ACCESS REPORT

DEVELOPMENT APPLICATION CERTIFICATE PHASE

PROPOSED BURMESE BUDDHIST TEMPLE

53 DWYER RD, BRINGELLY

Doorways / Doors –

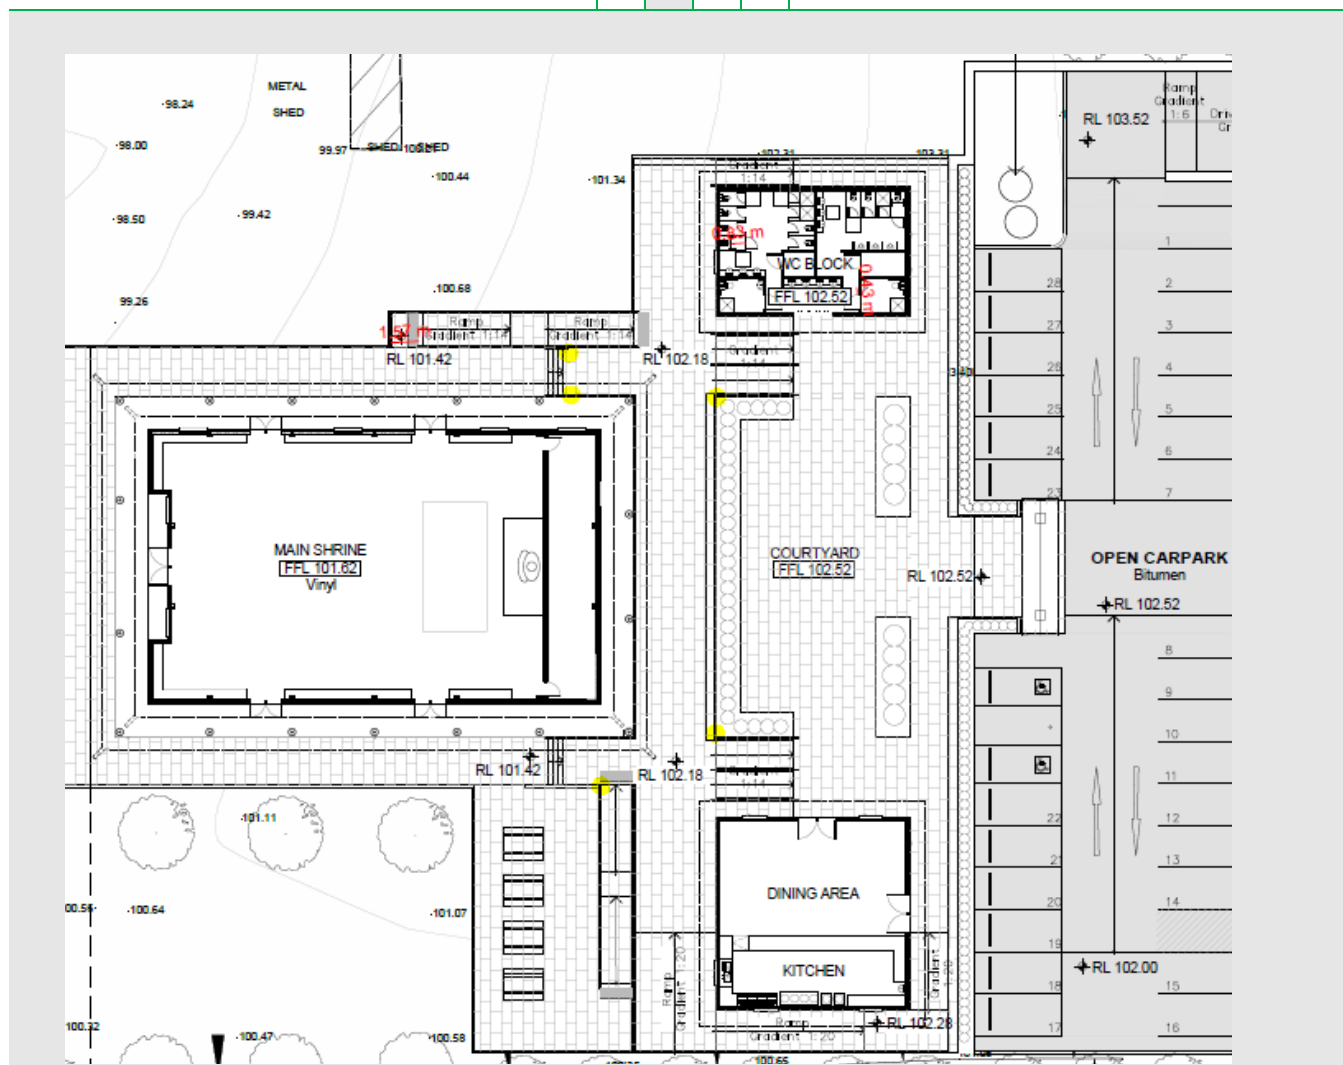
- (i) All doorways shall have a minimum luminance contrast of 30% between –
 - door leaf and door jamb;
 - door leaf and adjacent wall;
 - architrave and wall;

- door leaf and architrave;
 - door jamb and adjacent wall.
- (ii) The minimum width of the area of luminance contrast shall be 50mm,
- (iii) Door hardware should be generally located between 900-1100mm from the floor and be of lever type with a clearance between the handle and the door face at the centre of the handle being not less than 35mm and not more than 45mm in accordance with AS1428.1-2009,

- (iv) Doors shall have a clear opening width of 850mm. Includes on leaf of all double doors.
- (v) Door handles and related hardware shall be of the type that allows the door to be unlocked and opened with one hand. The handle shall be such that the hand of a person who cannot grip will not slip from the handle during the operation of the latch.
